City of Portland

Development Review Application
 Planning Division Transmittal form

Application Number: 2012-601 **Application Date:** 9/19/2012 12:00:00
CBL: 444-A-1 AM
Project Name: Casco Bay Ferry Terminal Improvements
Address: 56 Commercial Street

Project Name: Casco Bay Island Transit District
Address: 56 Commercial Street
Applicant: Casco Bay Island Transit District
Planner: Nell Donaldson

PANEL 14 OF 17
(SEE MAP INDEX FOR PANELS NOT PRINTED)

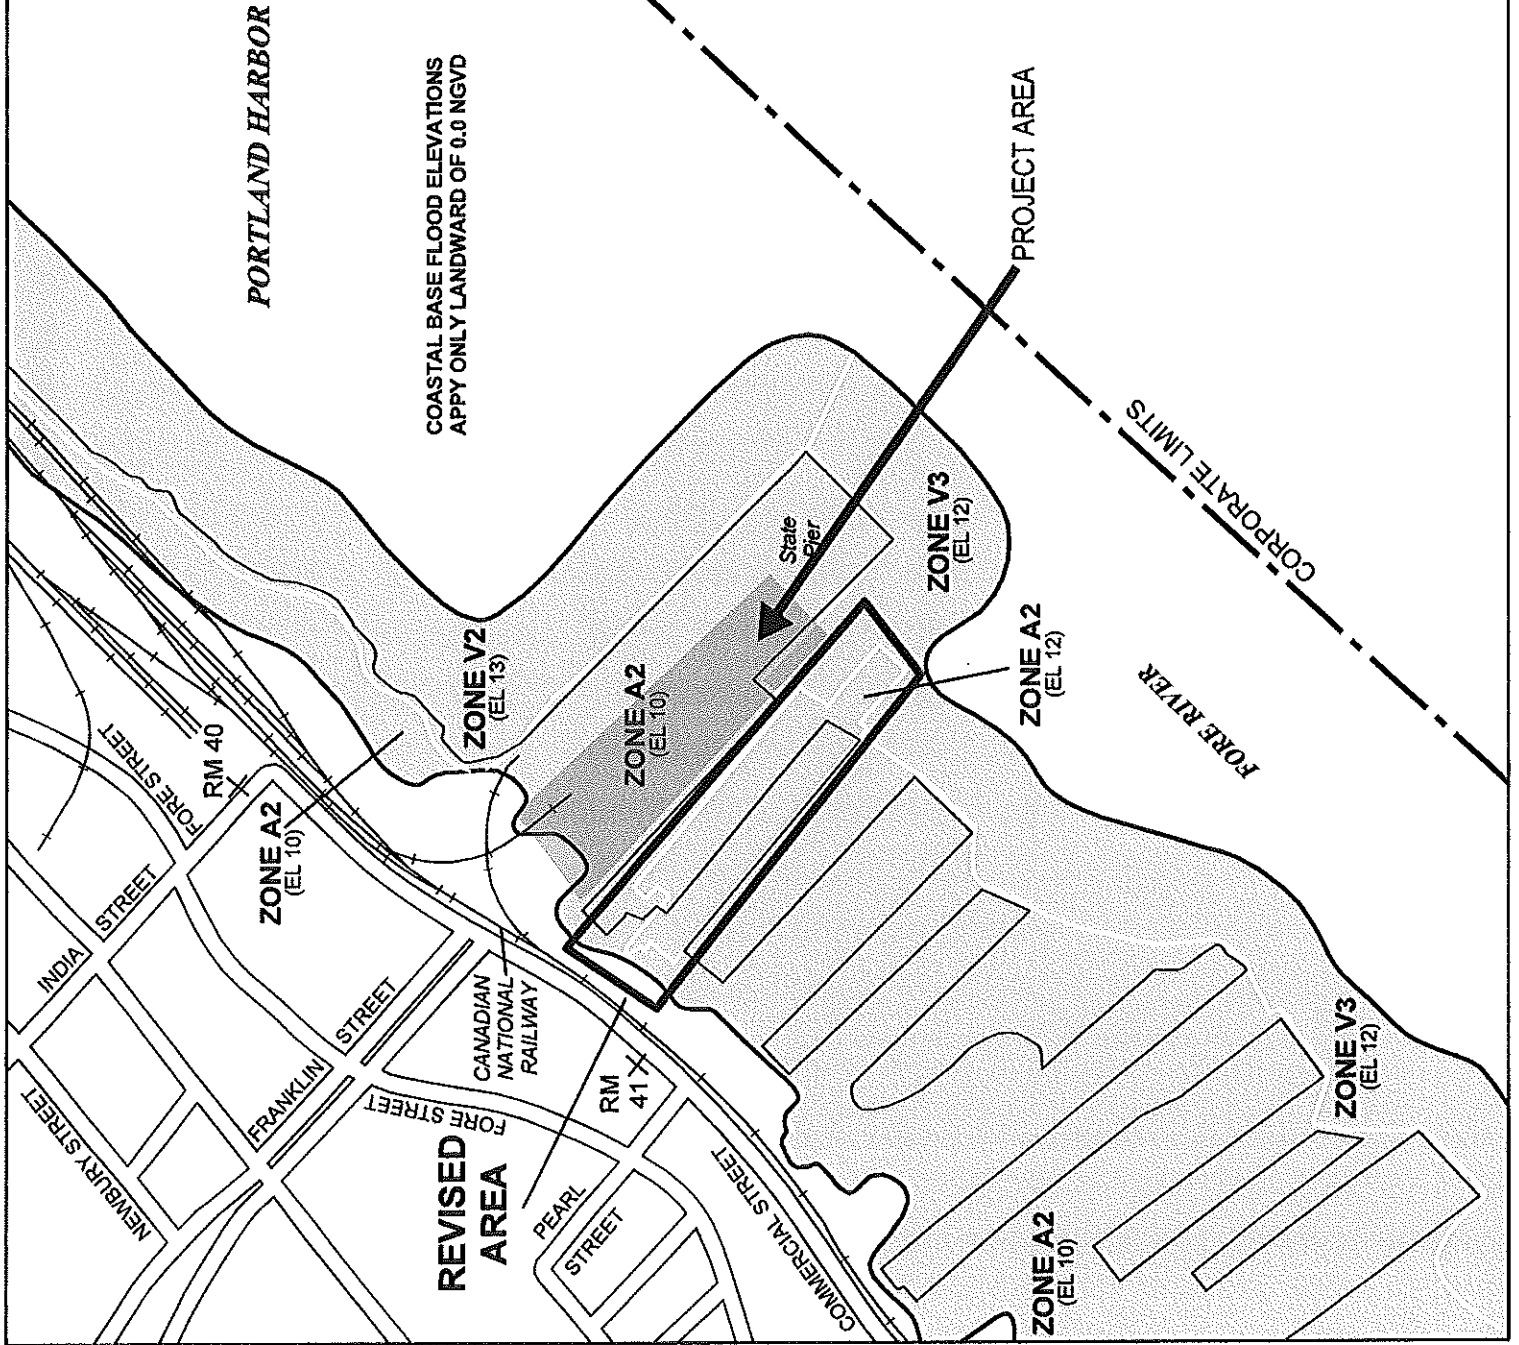
I had a quick question for you with regards to the flood elevation listed on the second condition of approval. Attached is the FEMA FIRM for our area. FEMA lists a base flood elevation of 10 ft NGVD, while your approval letter references 9.6 ft. Regardless, at 12.33 feet, our finish floor elevation will be greater than 2' above the base flood elevation, but I wanted to check with you to see where the 9.6 value came from so that we are consistent when we submit the elevation certificate. I've cc'ed Marge here, as she may know too.

It is my understanding that the most correct way is to determine elevation is to use the Flood Insurance Study that was issued by FEMA when we first received our maps. The study more accurately pinpoints the elevations, instead of the rounding up or down on the maps. I was going to send you a copy of it, but my "G" drive with the information is down. If you are at tomorrow's meeting I can bring you what I am talking about. Or I may shut down my computer to night and see if rebooting corrects my problem. There is a method behind my madness.
Marge

FOUNDATION PLAN
TERMINAL BUILDING

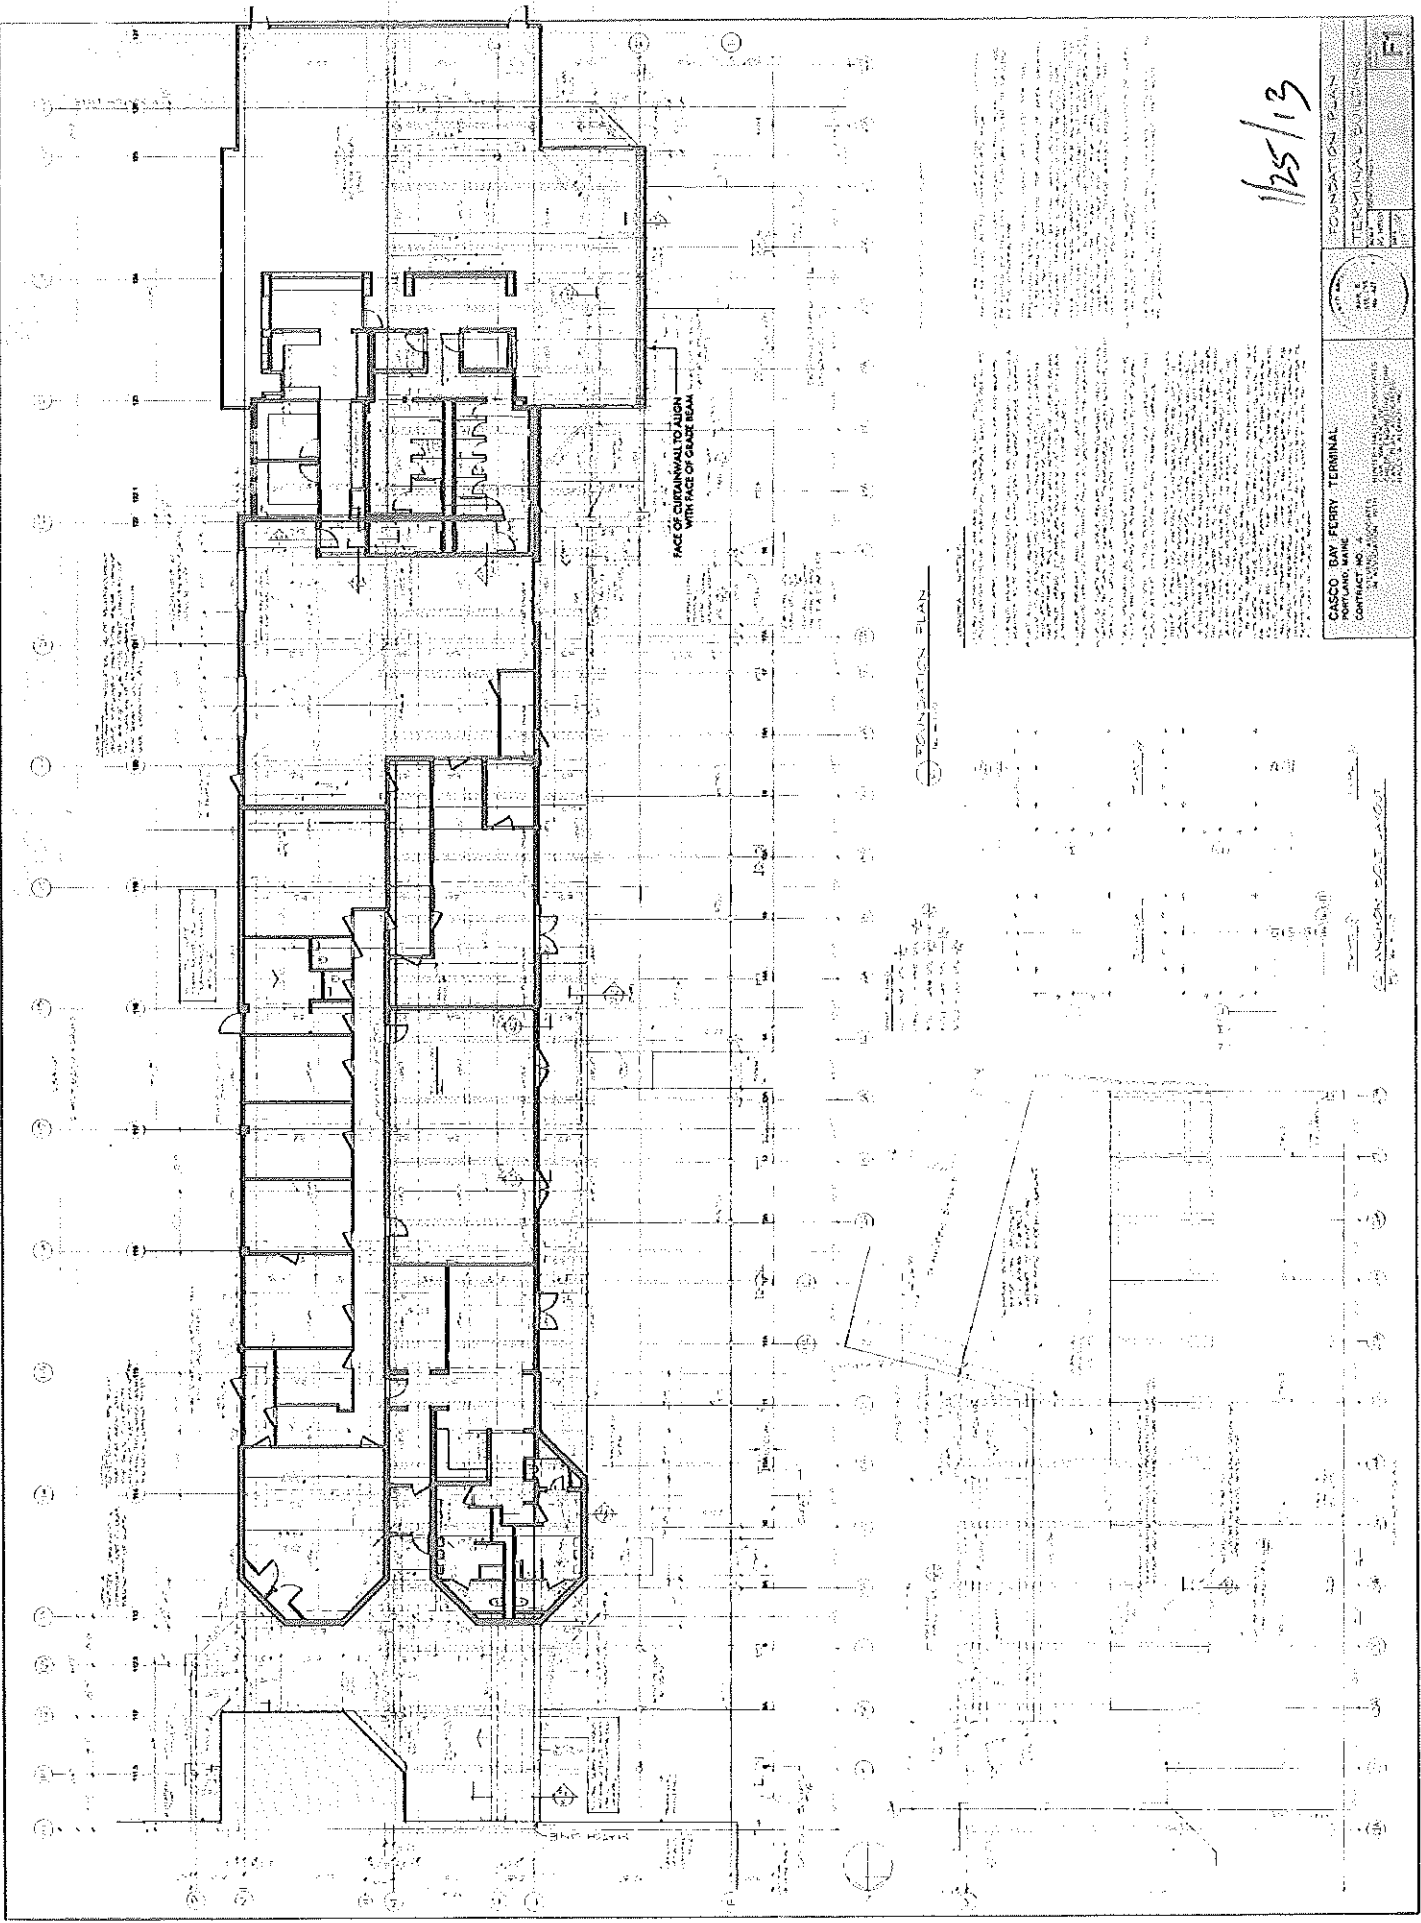
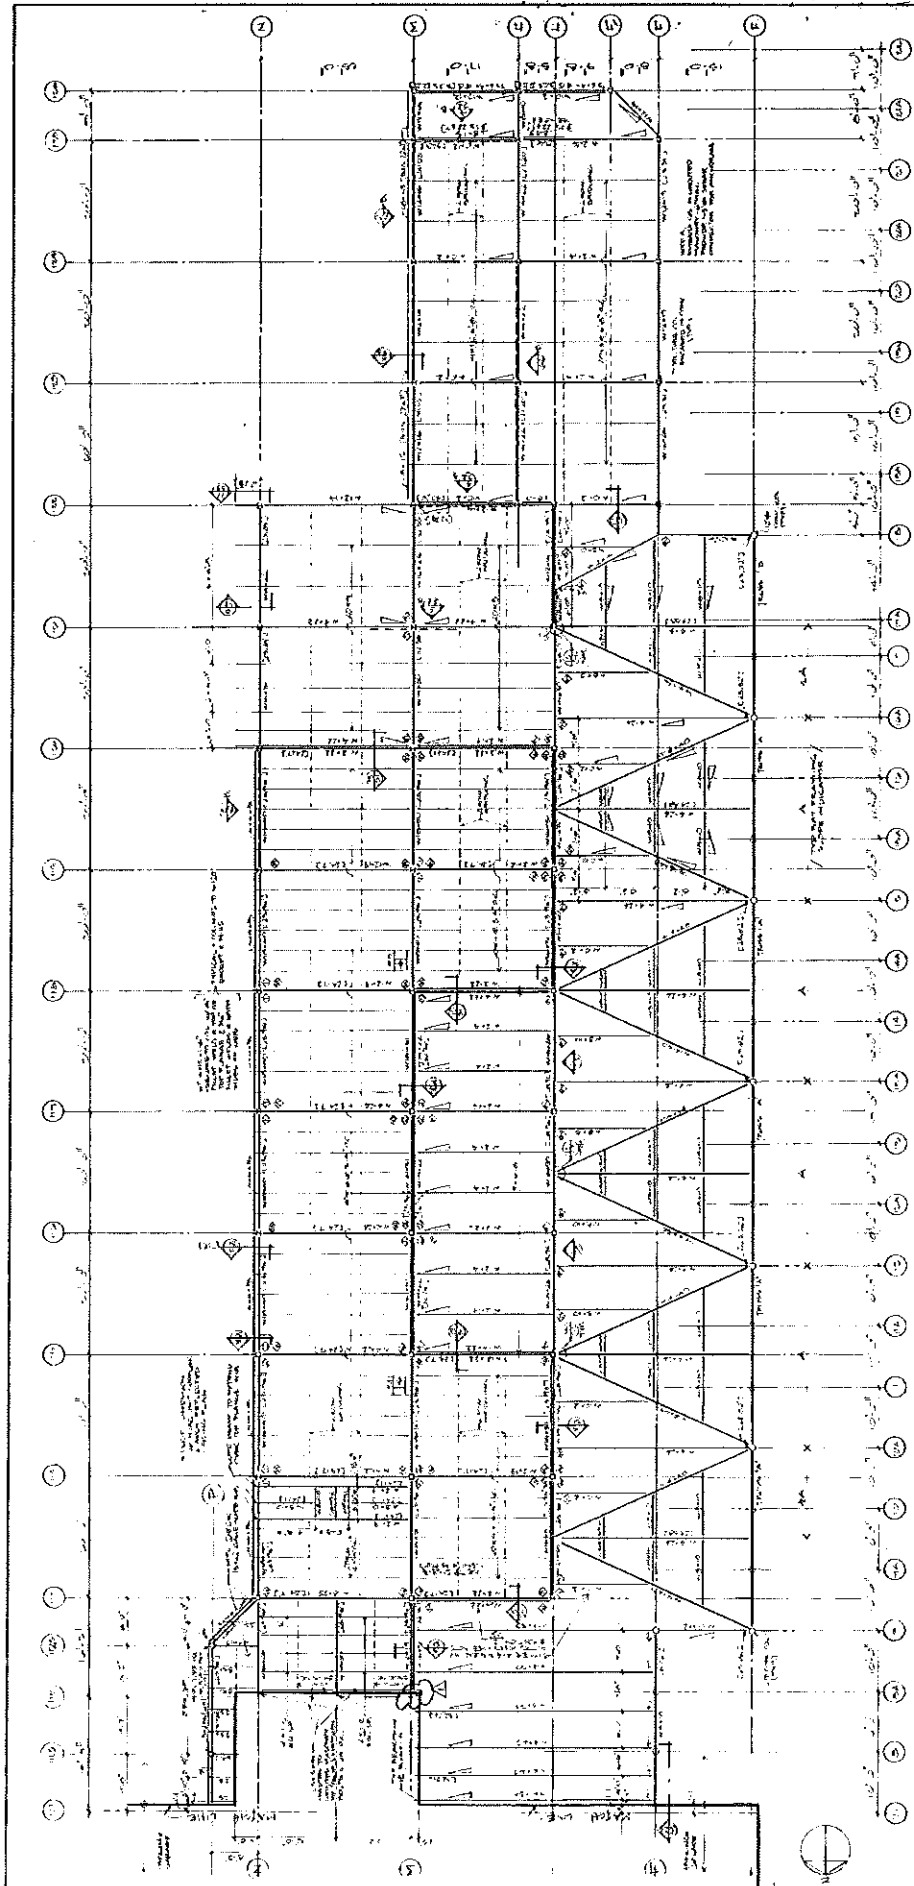
On 1/24/2013 I met with Austin Smith of Simon Architects and Peter Plumb of Murray Plumb and Murray. Austin had the original plans of the building when it was first built. He showed me that the supports that held up the existing building are the same supports that will be holding up the new building from the piers under the decking to upward and supporting the roof. They are the same in support then and now. They were able to get me an overlay of the proposed building on the original building plans. They match. There are no changes to the location of those supports. Therefore, I have concluded that the current structure is legally nonconforming for the setback. And that there are rights to rebuild within that legal nonconforming setback if done within one year. And further more I have determined that the proposed structure and project is in compliance with the Land Use Zoning Ordinance.

I've attached electronic copies of the documents we discussed. (Drawings F1 & S1, dated 11.19.86)
We have also added a layer showing our proposed construction in red, as you requested.
